# Access Compliance Report Public Rights-of-Way (Curb Ramps)

Main Street: W\_RANDOM\_DR Cross Street: GILBERT\_ST Location: NW

ADA ID: RPRK210927135322 Ramp Type: Type 1 - Perpendicular Diagonal Initial Pass/Fail: Fail Overall Compliance: No Severity Score: 16

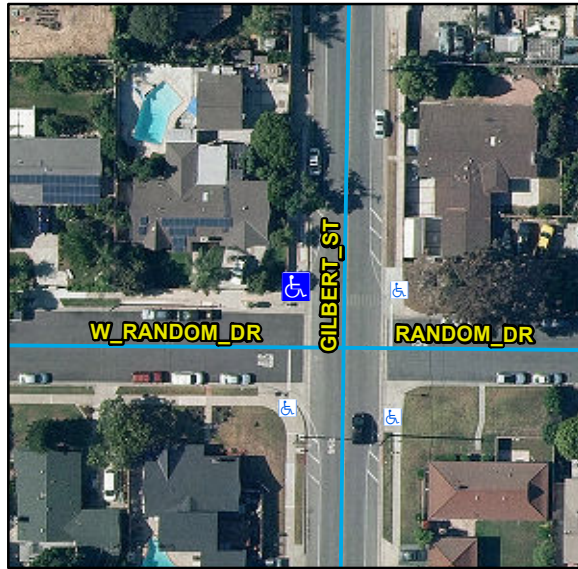
| Compliance | Description                                  | Data | Compliance | Description                   | Data |
|------------|----------------------------------------------|------|------------|-------------------------------|------|
| No         | Ramp Run Slope (%)                           | 11.4 | N/A        | Flare Slope LT (%)            | N/A  |
| No         | Ramp Cross Slope (%)                         | 3.1  | N/A        | Flare Traversable LT          | N/A  |
| No         | Gutter Lip Height (in)                       | 0.5  |            | Road Run Slope (%)            | 3.6  |

**Remove & Replace Curb Ramp With Two New Directional Ramps or Equivalent. Grind Gutter Lip.**

**R204.3, R304.2.2, R304.5.3, R302.7.2, STD 1115**
